SIB 71 01 26

DELIVERY STOP: VIN LABEL

This Service Information Bulletin (Revision 1) replaces SI B71 01 26 dated February 13, 2026

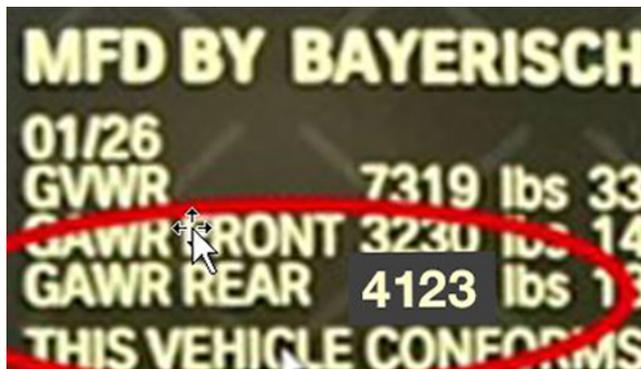
On G07 vehicles, the VIN-specific type plate (aka Manufacturer's certification placard/label) on the driver's B-pillar has missing information. Instead of displaying the correct maximum permissible rear axle load (GAWR) in American pounds (lbs), the type plate shows two horizontal lines (circled).

The correct maximum permissible axle load is 4123 lbs.

Replace the type plate on the lower B-Pillar.

1. Remove the type plate from the driver-side B-pillar (circled). Light heat may be needed.
2. Remove all adhesive residue using a suitable cleaner.
3. Apply activator 205 thinly and sparingly in area of type plate.
4. Allow 2 minutes of drying time.

5. Attach the new type plate with the correct GAWR of 4123 lbs, using the same positioning as the original.
  - Press firmly over the entire surface for maximum adhesion
